**ADDENDUM NO. 1**

PROJECT TITLE:  
**BRIDGE NO. 03160A-D, 3301 & 3303 I-84 EB/WB OVER AMTRAK & LOCAL ROADS (AETNA VIADUCT)**

TOWN: **HARTFORD**  
DRAWING TITLE:  
**SUBSTRUCTURE REPAIR - BRIDGE 3160B PIER NO. ES3**

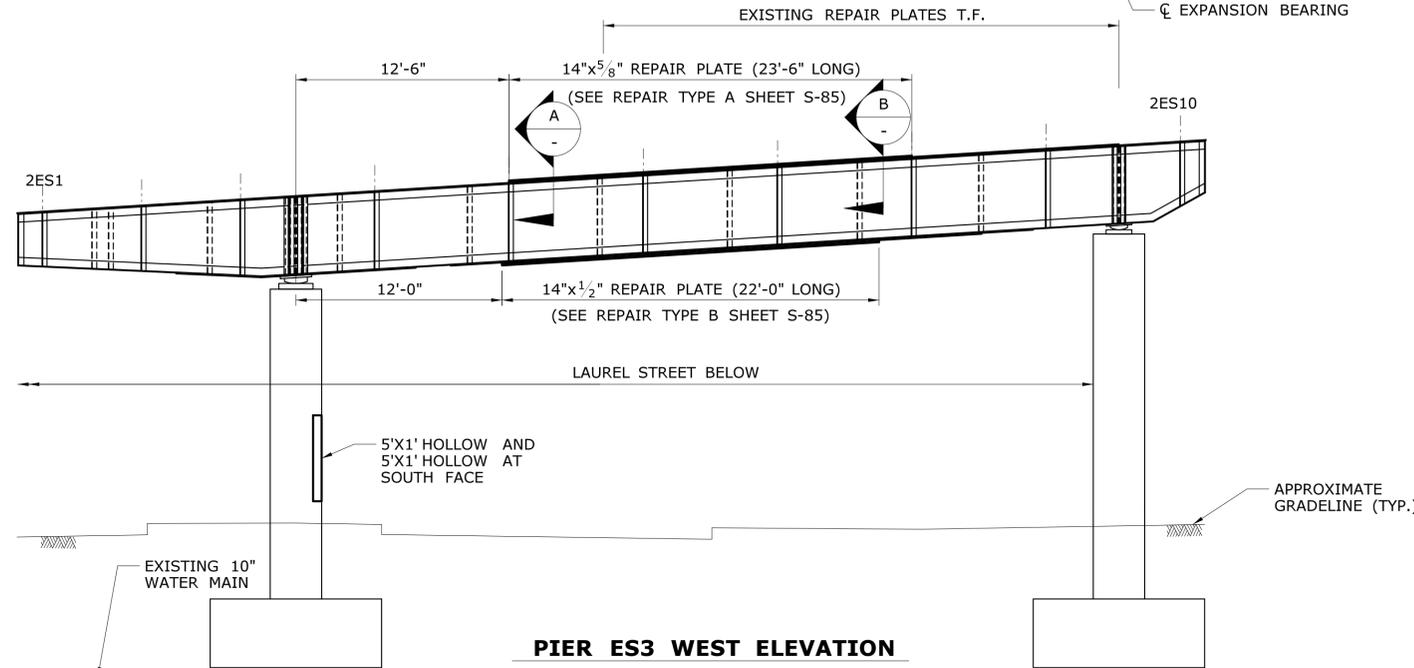
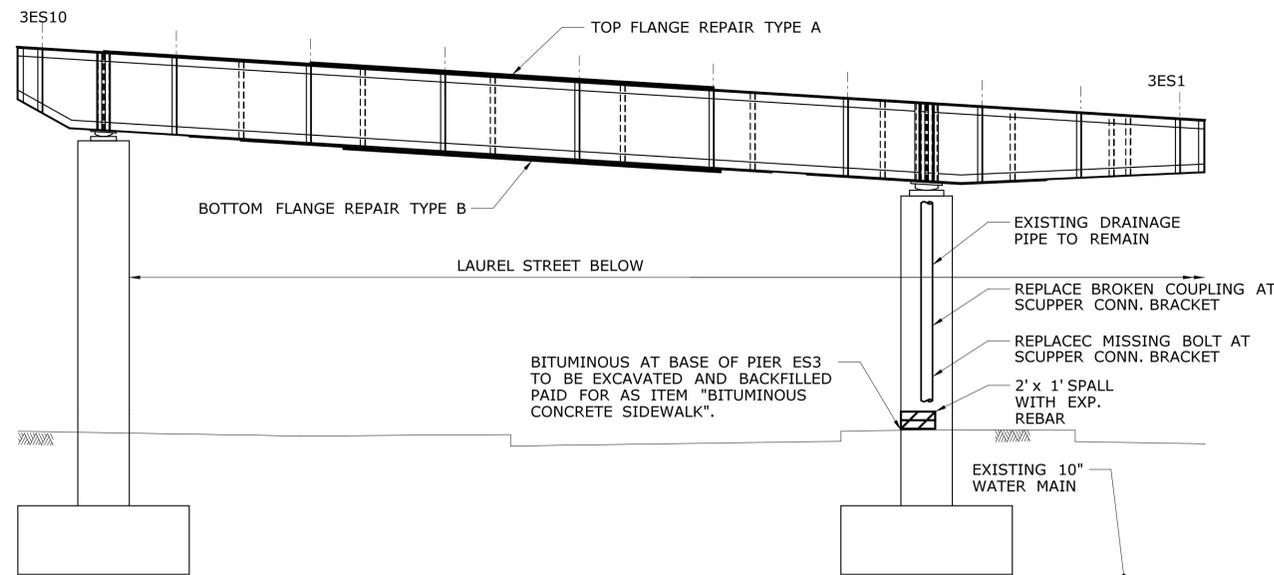
REV.	DATE	REVISION DESCRIPTION	SHEET NO.
1	9/29/16	PLOT LIMIT MODIFICATION	01.08.059

DRAWING NO.: **S-104**

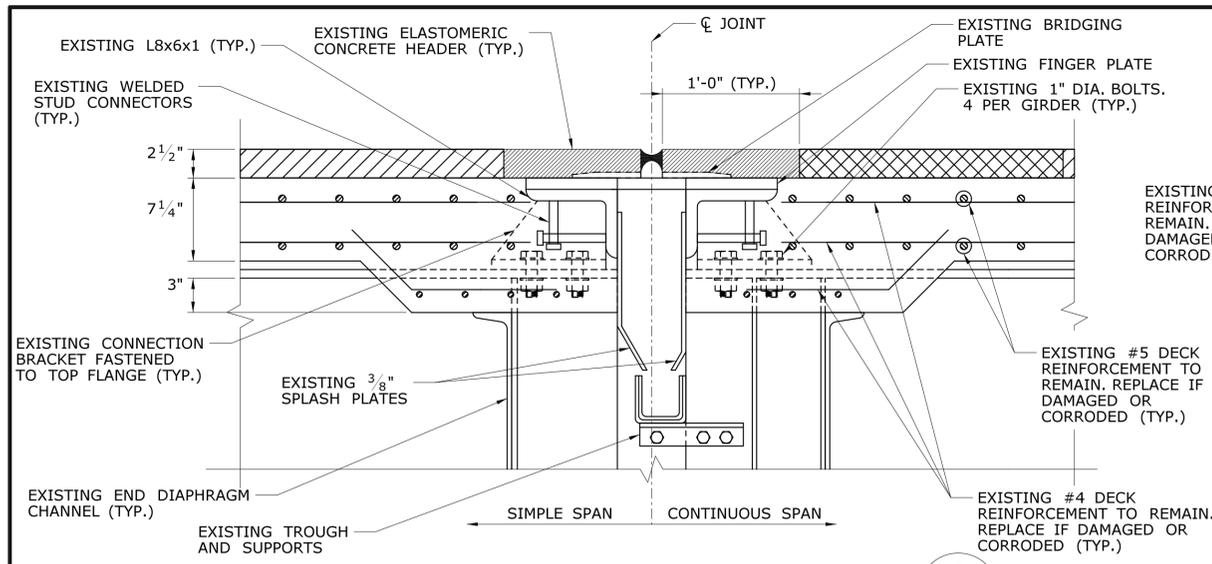
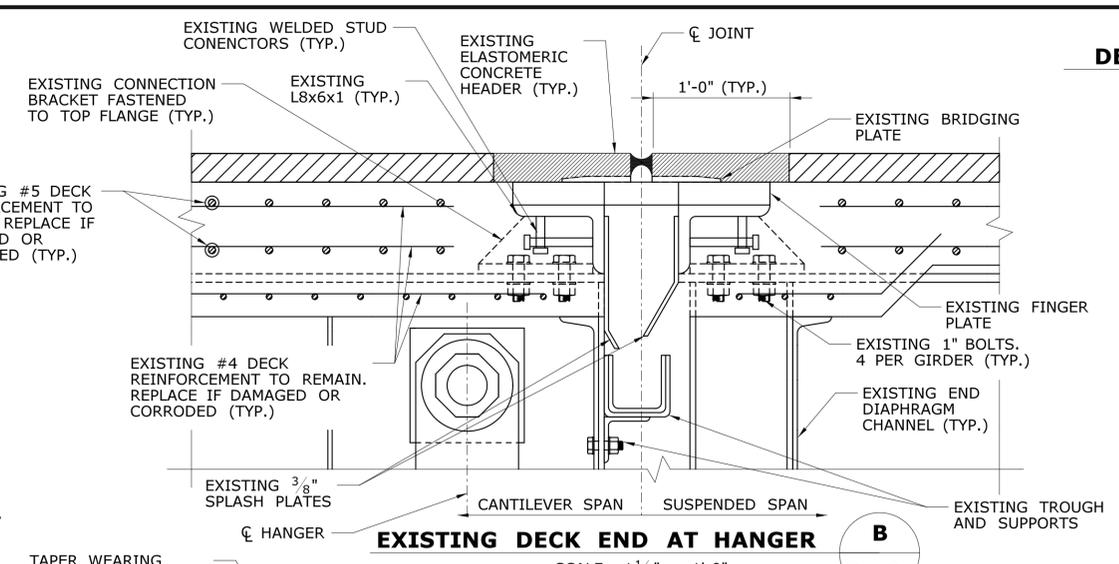
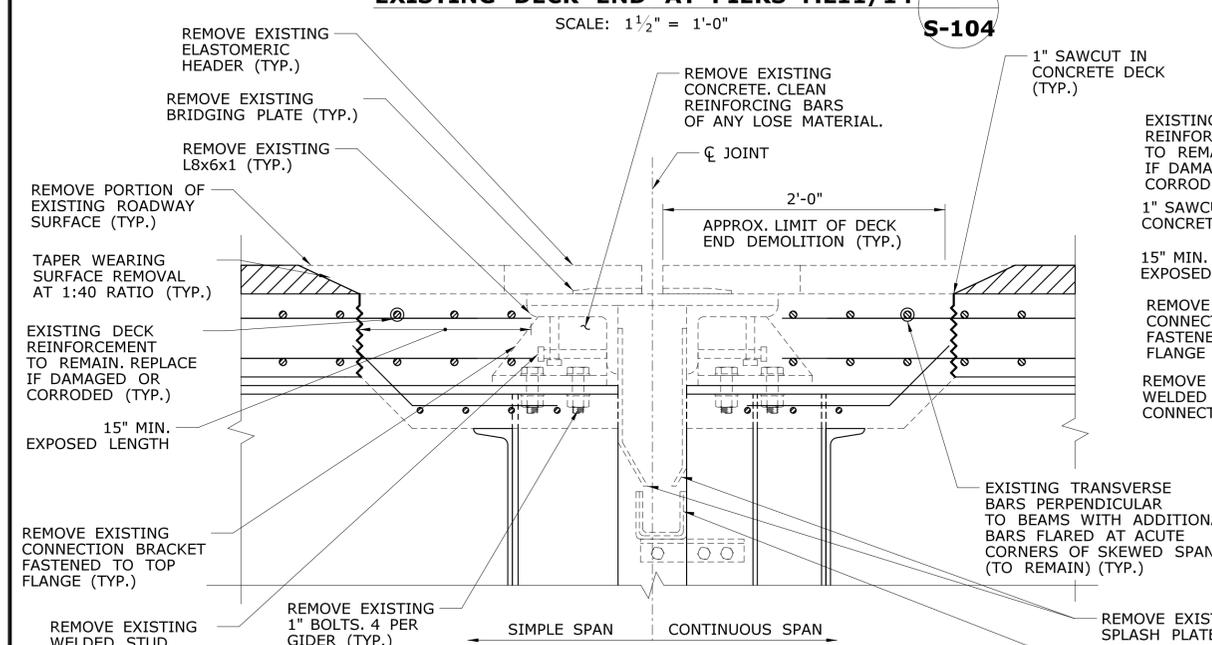
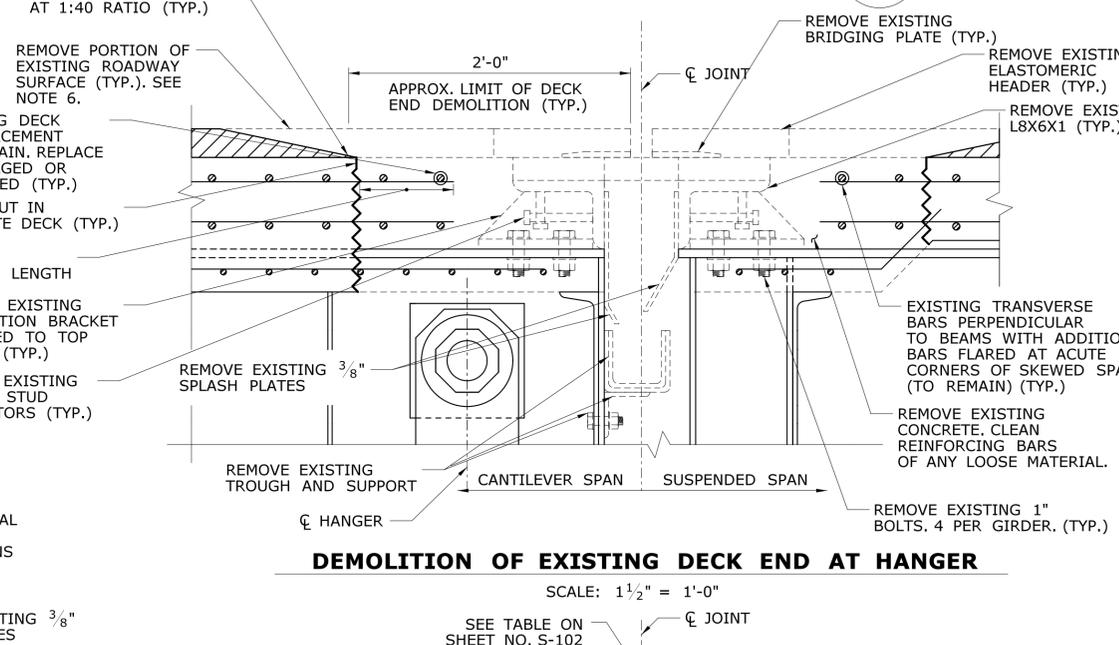
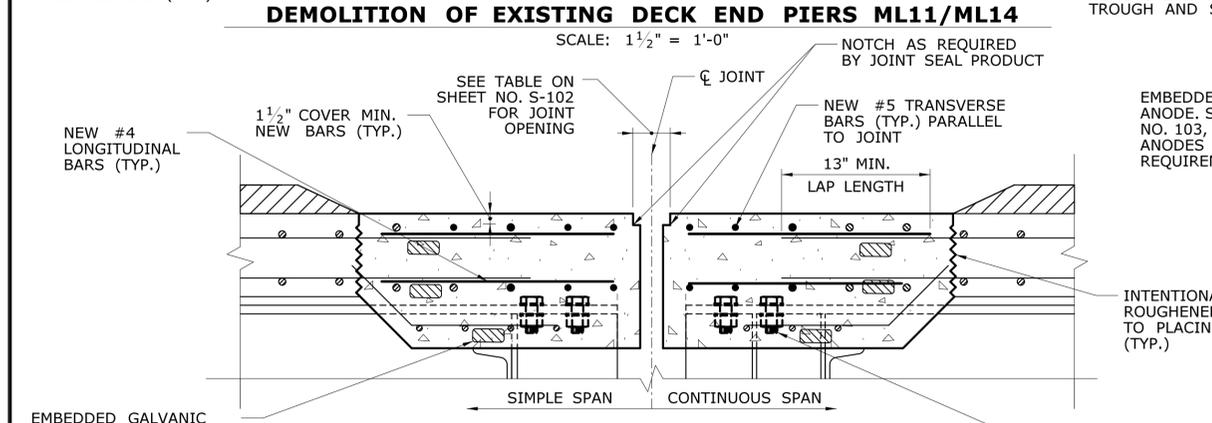
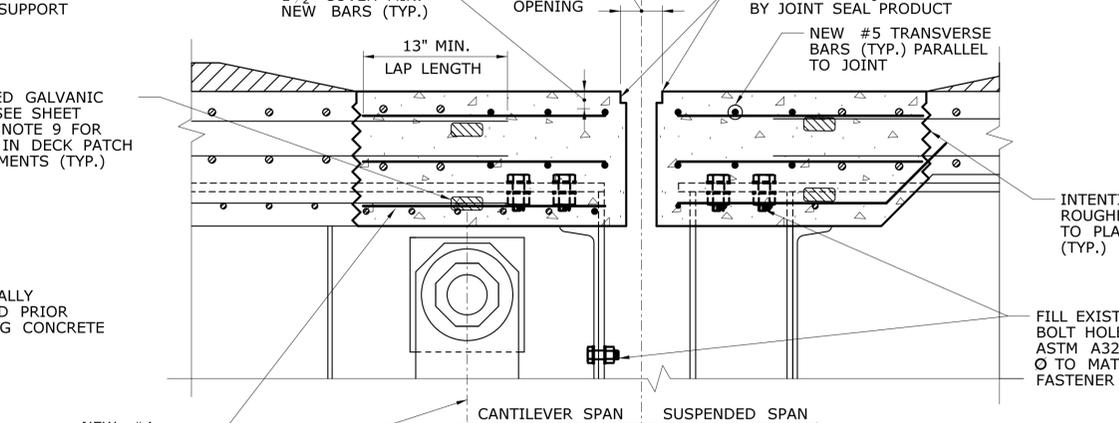
REV.	DATE	REVISION DESCRIPTION	SHEET NO.
1	9/29/16	REVISED STAGING DETAILS	10.08.108
		REVISION DESCRIPTION

- REMOVAL AND RECONSTRUCTION BEYOND THE STAGE 2 LIMIT OF DEMOLITION TO BE PERFORMED UNDER MEDIAN REPLACEMENT.
- FOR ADDITIONAL CONSTRUCTION STAGING SEE SHEET STG-02 THROUGH STG-05.
- SEE SHEET S-105 FOR SECTIONS "A" AND "B".
- CONSTRUCTION STAGING SHOWN ON THIS SHEET SHALL BE COORDINATED WITH PROJECTS 63-700 AND 63-701.
- EASTBOUND AND WESTBOUND WORK SHALL NOT BE SIMULTANEOUS.
